Title		
Size: A	Number	Revision
Date: 1/26/2024		Sheet of
File: C:\Users\..\Top_sheet.SchDoc		Drawn By:

Title		
Size: A	Number	Revision
Date: 1/26/2024		Sheet of
File: C:\Users\..\Power_Section.SchDoc		Drawn By:

Title		
Size A	Number	Revision
Date: 1/26/2024		Sheet of
File: C:\Users\..\Controller_Section.SchDoc		Drawn By:

Title		
Size: A	Number	Revision
Date: 1/26/2024	Sheet of	
File: C:\Users\..\Transmitter_Receiver_Section.SchDoc	Drawn By:

100V BOOST REGULATOR

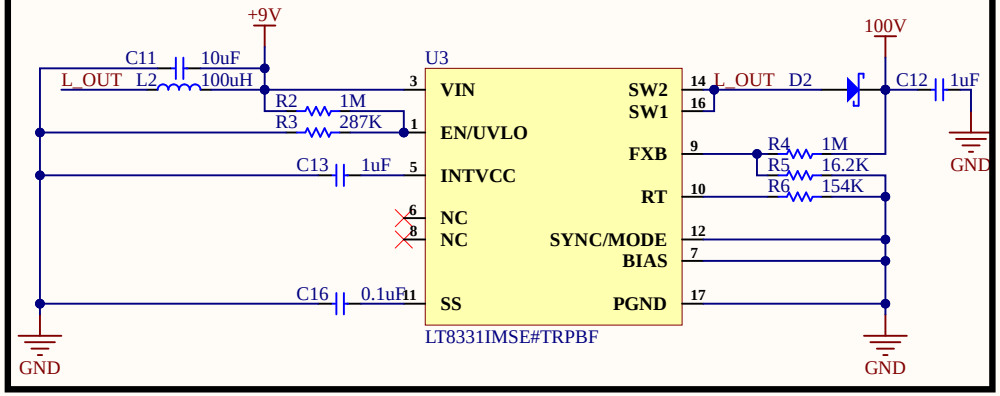
LT8331EMSE#TRPBF is out of stock from lcsc, may I used alternates [LT8331IMSE#TRPBF](stock = 105)
The Differnece between them is Operating juction temperature.

Connections in given schematic were different from reference schematic for R2 and C13.
Reference schematic from datasheet is followed for R2 and C13 connection

TRANSMITTER CIRCUIT

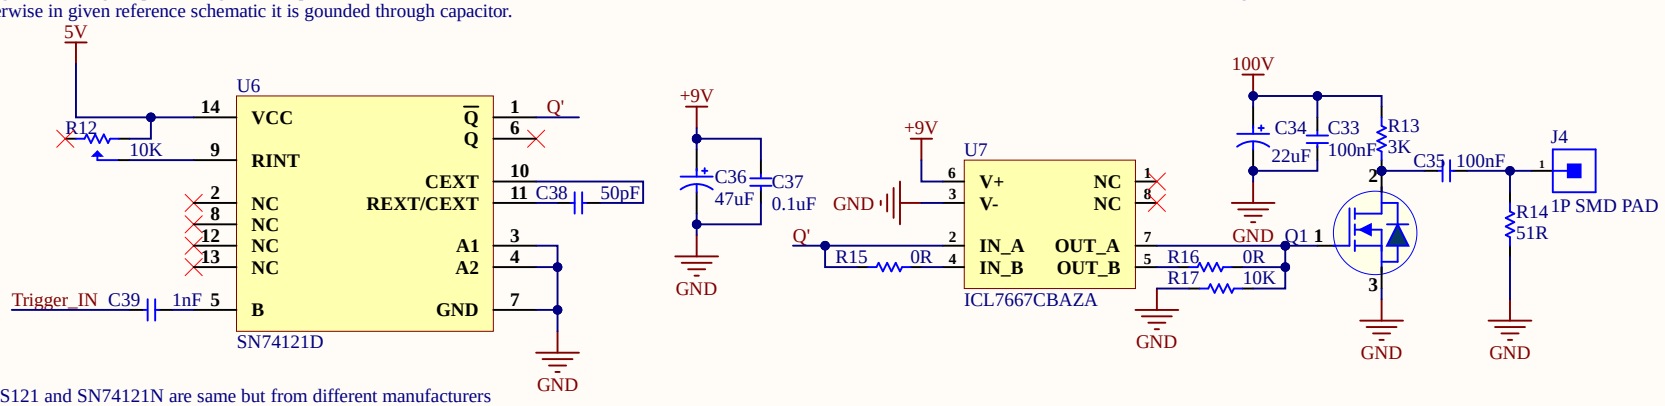
Trigger_IN through capacitor is given to input B,
otherwise in given reference schematic it is gounded through capacitor.

3kOhm (0.25W), 10kOhm (0.25W) and 50Ohm (1W) Required ratting mention in link

74LS121 and SN74121N are same but from different manufacturers
